## Development Review Committee

- 1. Discussion: Lake Hills Shopping Center - Preliminary Site Plan | Variance Application**

**TO:** Howey-in-the-Hills Development Review Committee  
**CC:** J. Brock, Town Clerk  
**FROM:** Thomas Harowski, AICP, Planning Consultant  
**SUBJECT:** Lake Hills Commercial 1/11/24 Resubmittal  
**DATE:** January 29, 2024

February 5, 2024  
Lake Hills Commercial Preliminary Site Plan  
Engineering Review Comments  
Page 1

WTP #3 &  
LAKE HILLS COMMERCIAL  
ACCESS PLAN

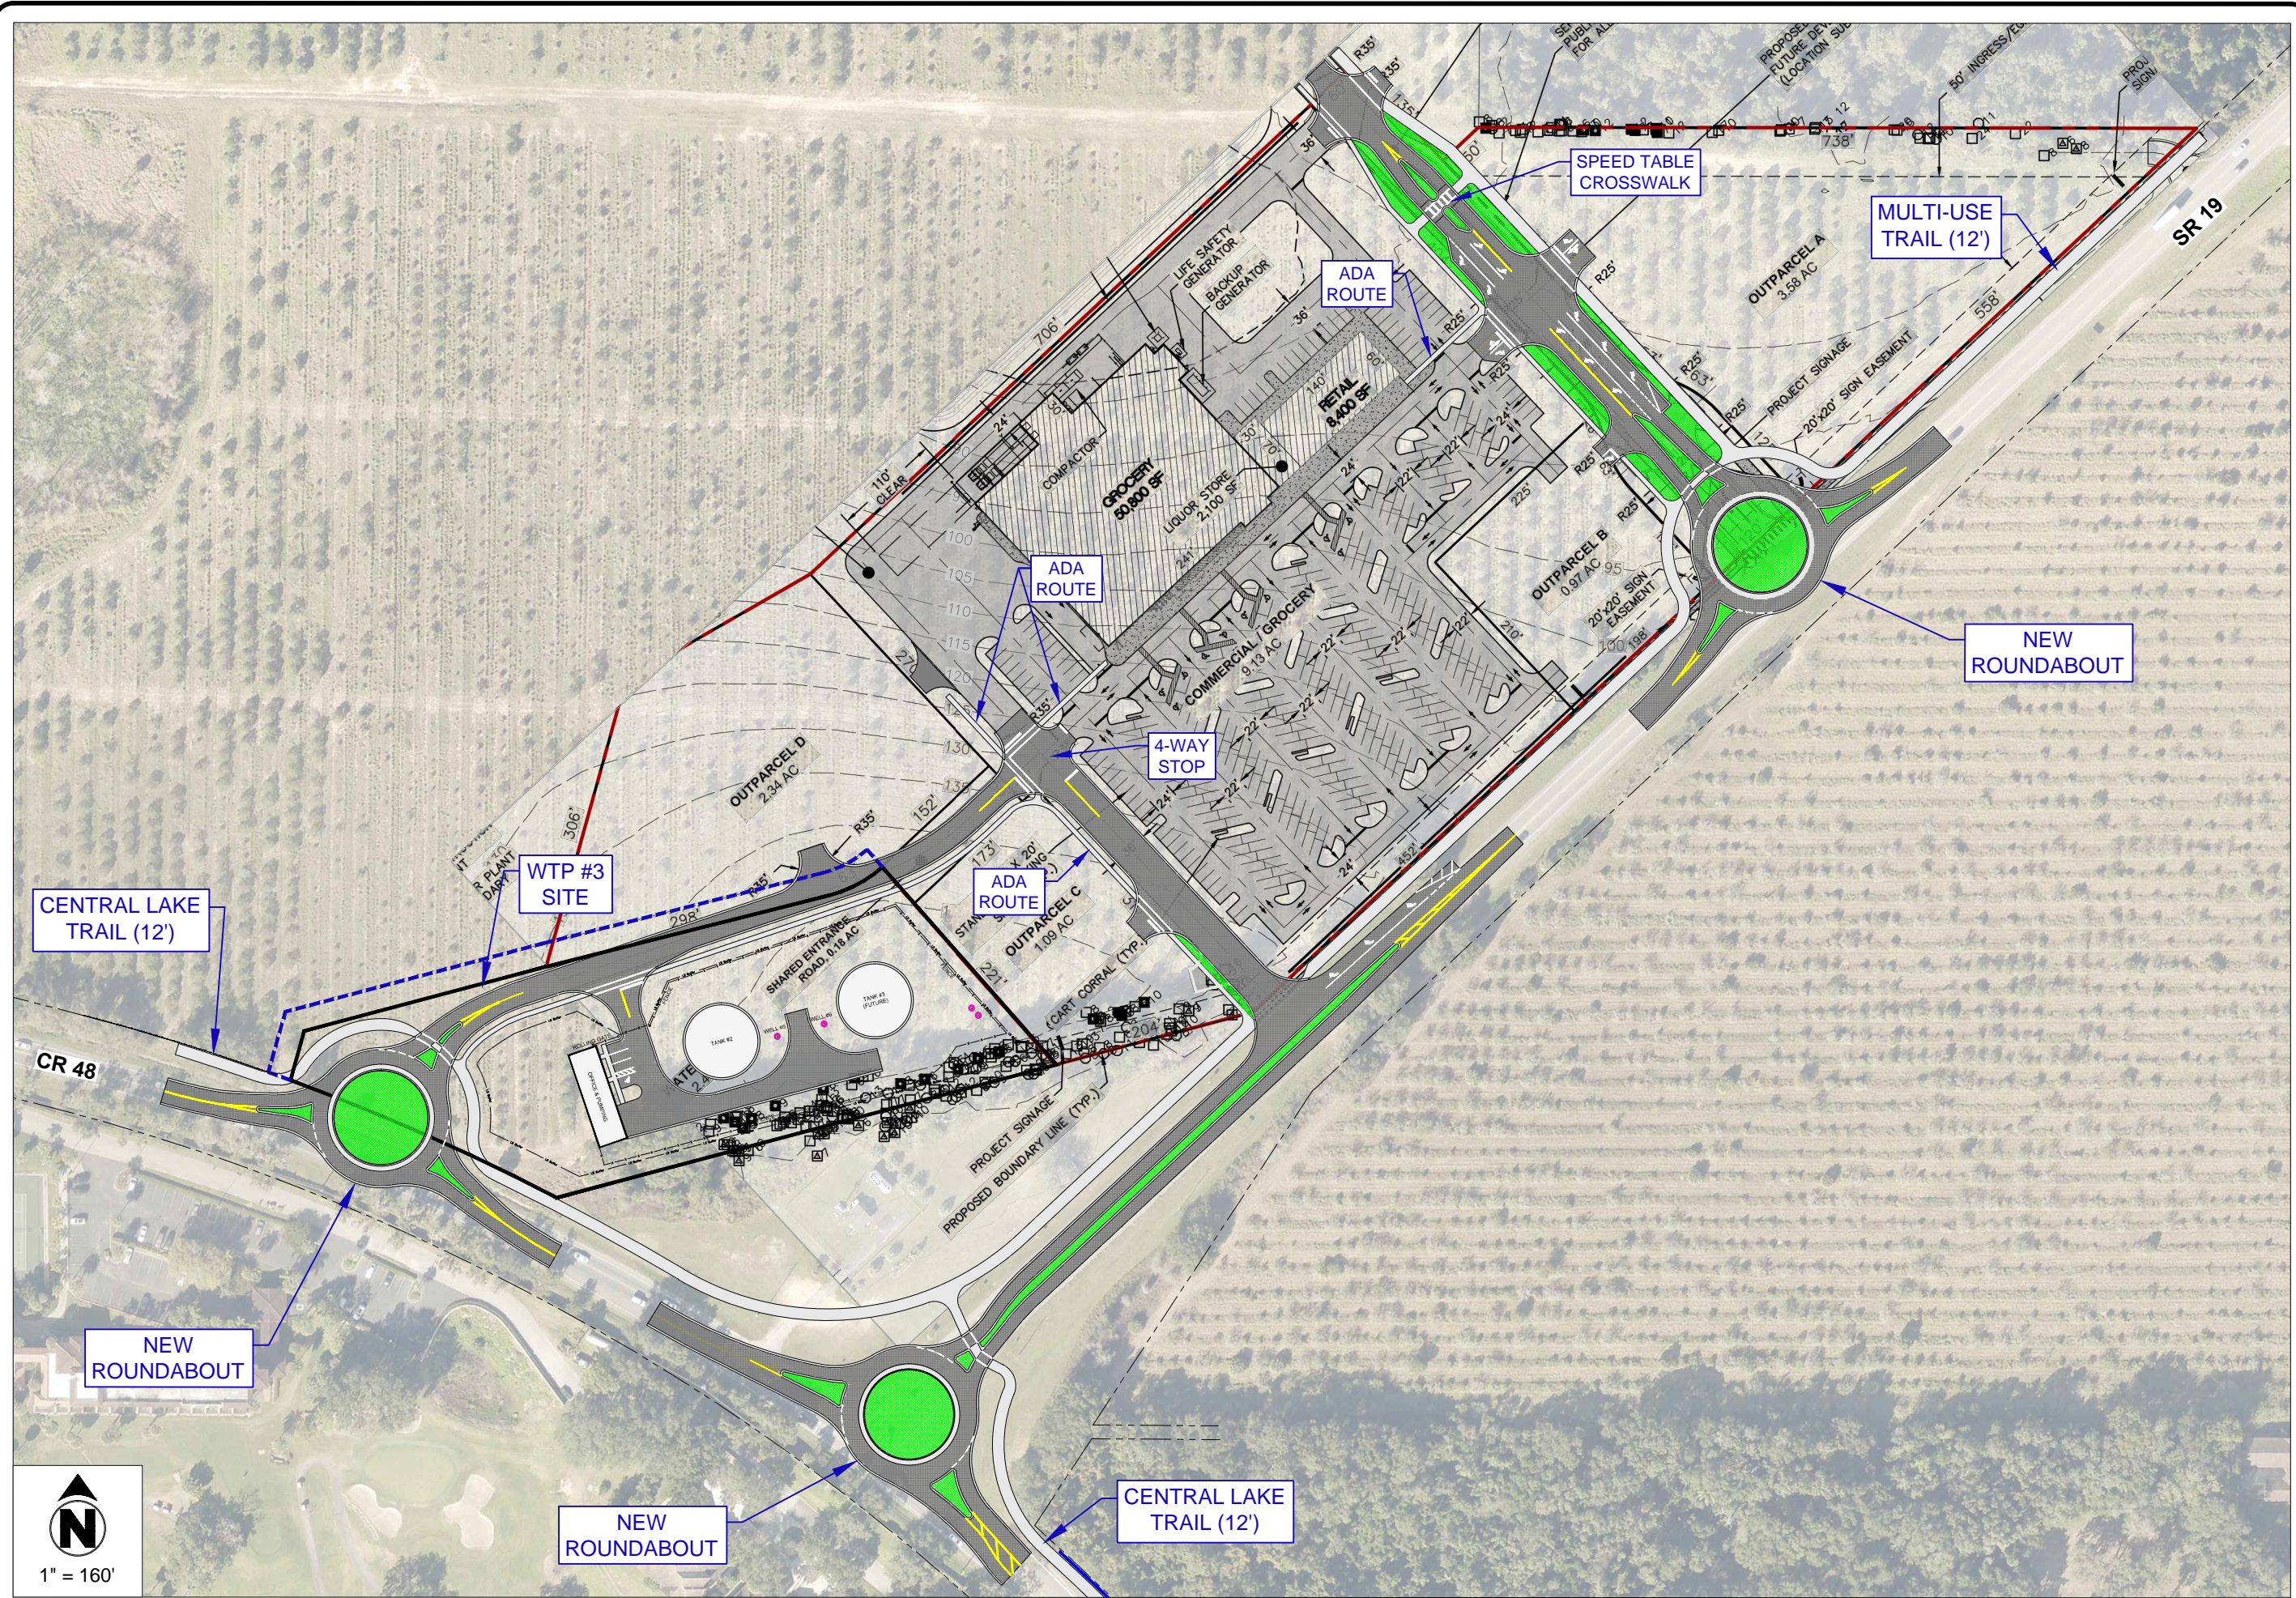
Access connections and offsite improvements need to be coordinated between the residential and commercial portions of Lake Hills PUD. The town is working with Lake County and FDOT to develop an improvement plan for this area. Approval of this preliminary site plan should include a condition that the final construction plans will incorporate those improvements. A copy of the most recent concept plan is included with these comments.

SR 19 & CR 48 Intersection: This intersection will need to be modified to accommodate future traffic. This should be an Impact Fee project through the Lake County road improvement program. Lake Hills PUD (residential and commercial) should provide a proportionate share contribution towards that project.

CR 48 & Commercial Side Entrance: This intersection would work best as a roundabout. It would provide full access and would eliminate the need for an easement through the commercial site to accommodate traffic from the water plant.

SR 19 & Project Entrance: This intersection would work better as a roundabout. It would function as a town & project gateway, it would slow down traffic coming into town, it would provide safer egress for project traffic, and it would eliminate the need of a future traffic signal.

C100

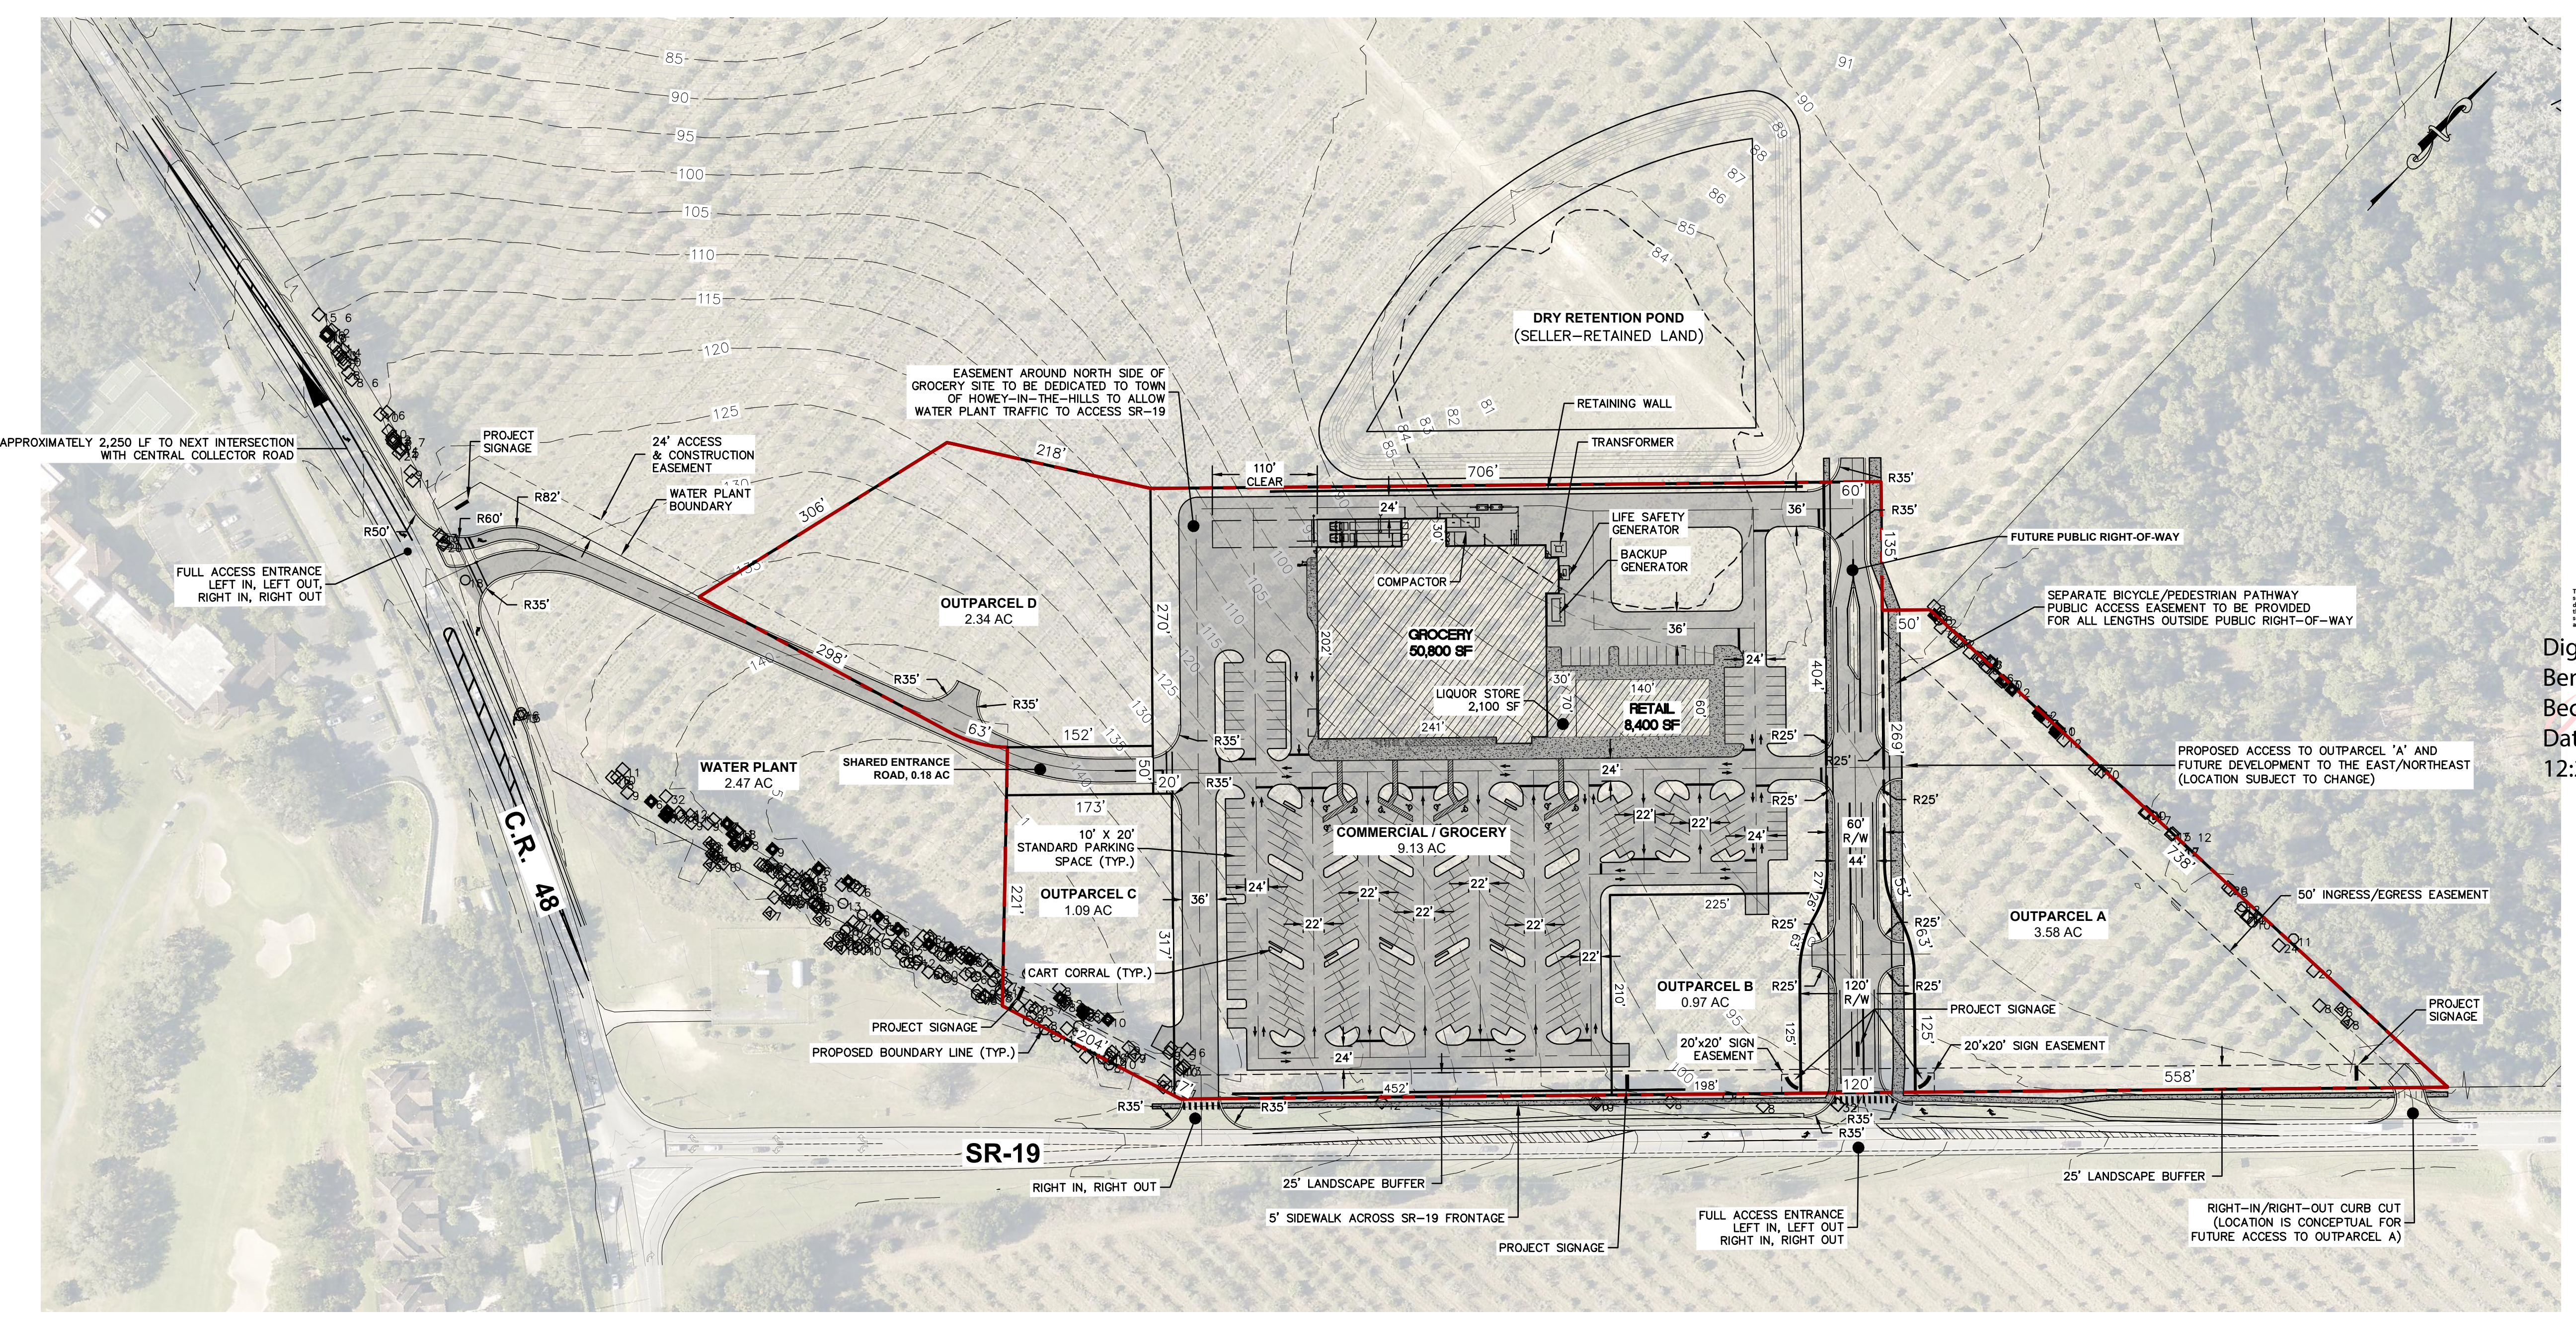
1. Response to Town Comment 3: The Town's engineer will need to evaluate the proposal excluding the noted lane omissions.
2. Response to Comment 6: This plan needs to show the proposed connection, even if the location needs to be revised once the development proposal for Outparcel A is submitted. This is the most effective way to keep track of the access commitment.

3. Response to Comment 11: The tree information is still unreadable. Enlarging the drawing did not result in a layout that can be reviewed. As noted in the last set of comments, the tree data is needed with the preliminary site and not deferred to a future submittal. In this case the trees seem to be at the periphery of the parcels, so preservation should be relatively easy. A calculation of historic and specimen trees is required and not provided. A tabulation is cited in the comment, but could not be located in the submittal package.

5. Response to Comment 17: While the detailed landscaping design may be deferred to the final site plan submittal, the designation of the landscaped buffer areas cannot be deferred (Section 7.01.01 B). The requested buffer along the rear property line is not identified on the plan and needs to be shown. This requirement applies to the exterior property lines of the outparcels as well.

6. Response to Comment 18: This response is inadequate. Deferring the required buffer until after a determination is made on the sale of the outparcel(s) is likely to result in there being no room for the buffer. Reading Section 7.02.02 requires a ten foot buffer along the property line of the primary parcel and the outparcels.

7. Response to Comment 21: The Town engineer will need to participate in decisions on site grading and retaining wall construction. Site grading should not result in the elimination of trees that could otherwise remain with the use of a retaining wall.

8. Outparcel A includes a 50-foot ingress/egress easement and a access from SR-19. Why are these proposed? To maintain traffic flow on SR 19, access points should be kept to a minimum.

9. The access to Outparcel C is too close to SR-19 and needs to be relocated.
10. The sidewalk on the SR-19 frontage needs to be extended across the front of Outparcel C.
